Increased Clock Speeds and Faster Initial Burst Access on Am29BDDI60G

Application Note

Modification to Burst Initial Access Delay Control and CFI Device Geometry Definition—Revision 4a versus Revisions 4 and Earlier

Figure 1. Burst Initial Access Delay Control

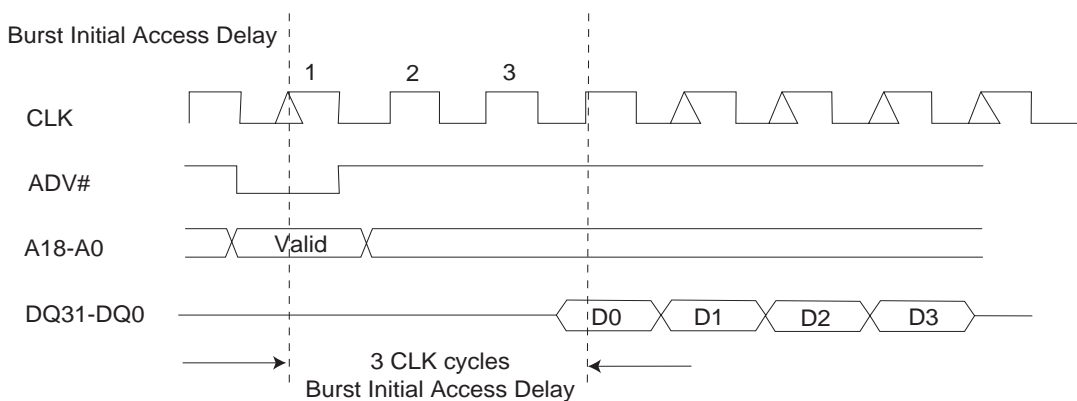
Design modifications have decreased the Burst Initial Access Delay by one clock cycle for all control register configuration values and for frequencies up to 66 MHz. Configuration Registers CR13 through CR10 determine the Burst Initial Access Delay. The Burst Initial Access Delay is defined as the number of CLK cycles that must elapse from the first valid clock edge after ADV# assertion (or the rising edge of ADV#) until the first valid CLK edge when the data is valid. Figure 1 and Table 1 are valid for the majority of applications, and have the following operating conditions:

For example, Revision 4 control register setting CR[13-10] = 0010 results in a Burst Initial Access Delay of five clock cycles; while Revision 4a the same control register setting results in a Burst Initial Access Delay with four clock cycles.
